City of Detroit
Inter-Departmental Communication

DATE: January 27, 2020

RE: Petition No.1148-Revision-B
Requested Encroachment into Second Ave. at 4128 Second In Block bound By
Second, Alexandrine, Cass, And Willis

PROVISIONS FOR ENCROACHMENT For Petition 1148

"REVISION-B-"

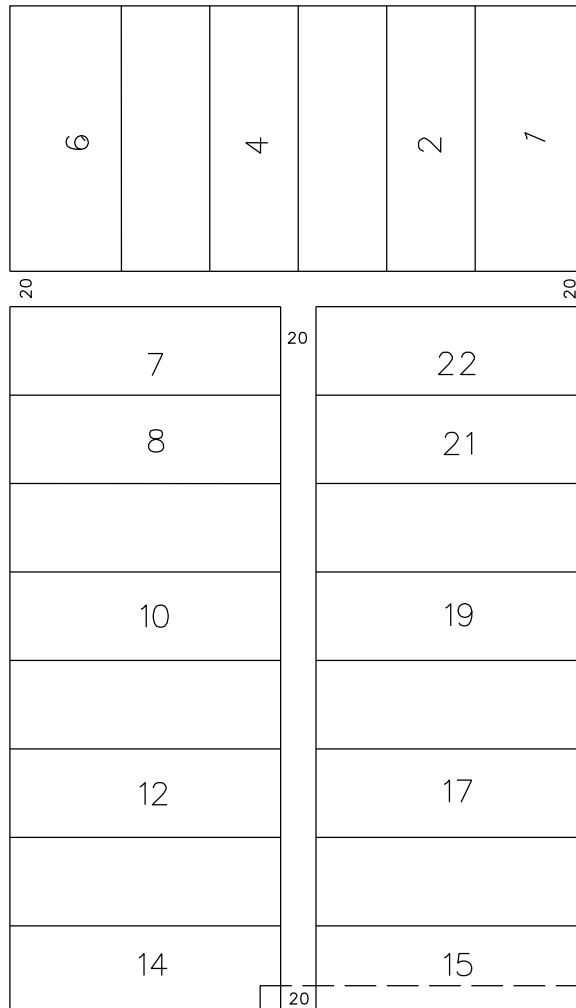
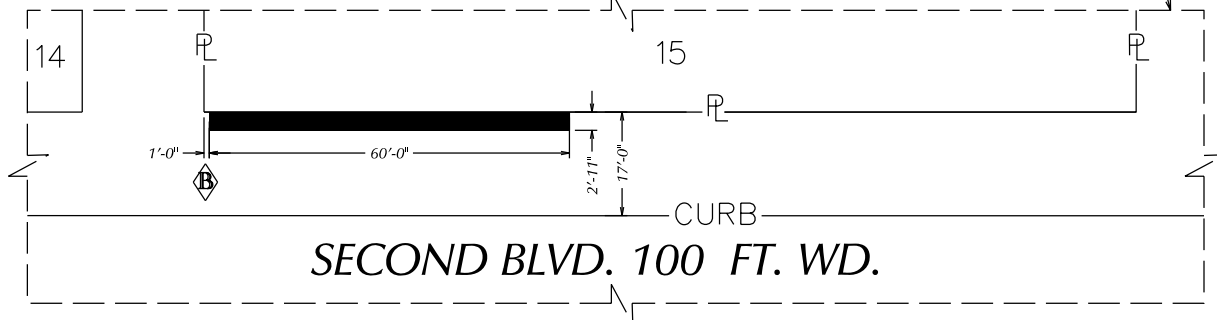
B	Revised: Correcting the distance between the north lot line of the property and the projecting sign	SA	KSM	JD	01/24/20
A	Revised: Removing the vestibule.	SA	KSM	JD	01/13/20
DESCRIPTION		DRWN	CHKD	APPD	DATE
REVISIONS					
DRAWN BY	SA	CHECKED		KSM	
DATE	12-11-19	APPROVED

"REVISION-A-"

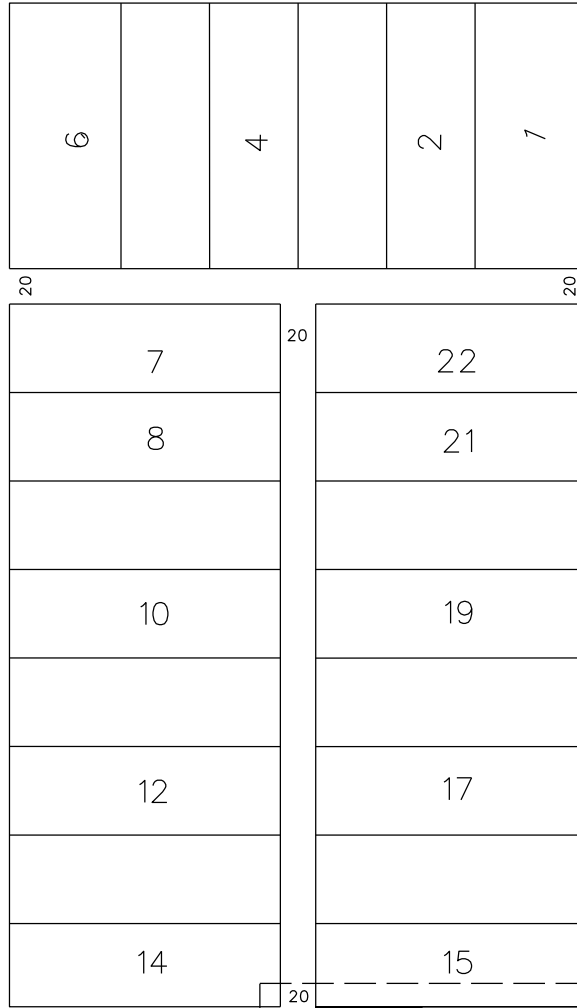
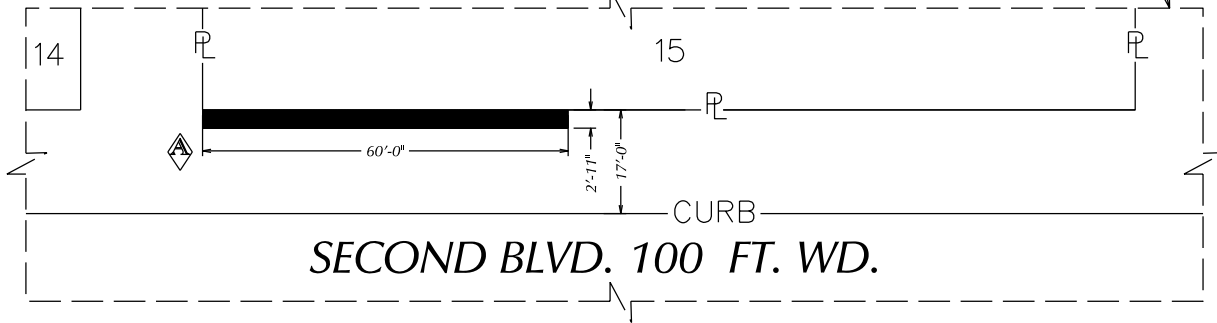
B					
A	REVISED: REMOVING THE VESTIBULE.	SA	KSM	JD	01/13/20
	DESCRIPTION	DRWN	CHKD	APPD	DATE
REVISIONS					
DRAWN BY	SA	CHECKED	KSM		
DATE	12-11-19	APPROVED
